STANDARDS SHEET

DRAWN	LAWSON	CLASSIFICATION	STANDARD
CHECKED	<i>[Signature]</i>	SEAL - EXTRUDED	CVR 134
STRESSED	<i>[Signature]</i>		
APPROVED	<i>[Signature]</i>

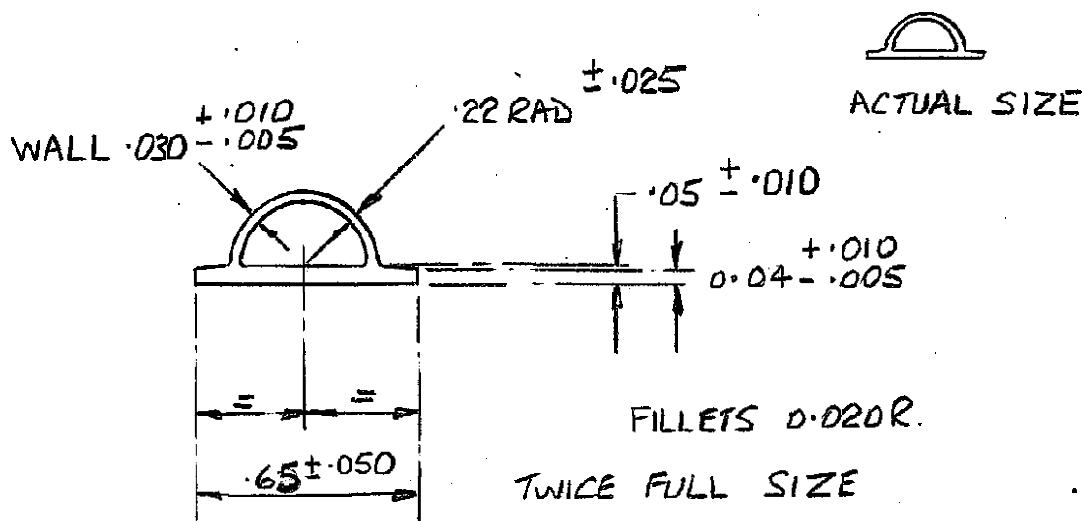
- (A) MATERIAL - 1 SAME AS CVR 134 EXCEPT THE $.030''$ WALL
SECTION OF SEAL SHALL MEET THE
REQUIREMENTS OF ~~(B) FAR 25.855(A-1)~~
~~AMEND 25-51 FAR 25.853(b-2) And 25-51~~
and 45° BURN THROUGH TEST ONLY OF FAR 25.855(A-1)
And 25-51.

(B) FLAMMABILITY CHANGED
REQUIREMENTS

- 1 ADDED
18. 25 MAR 85
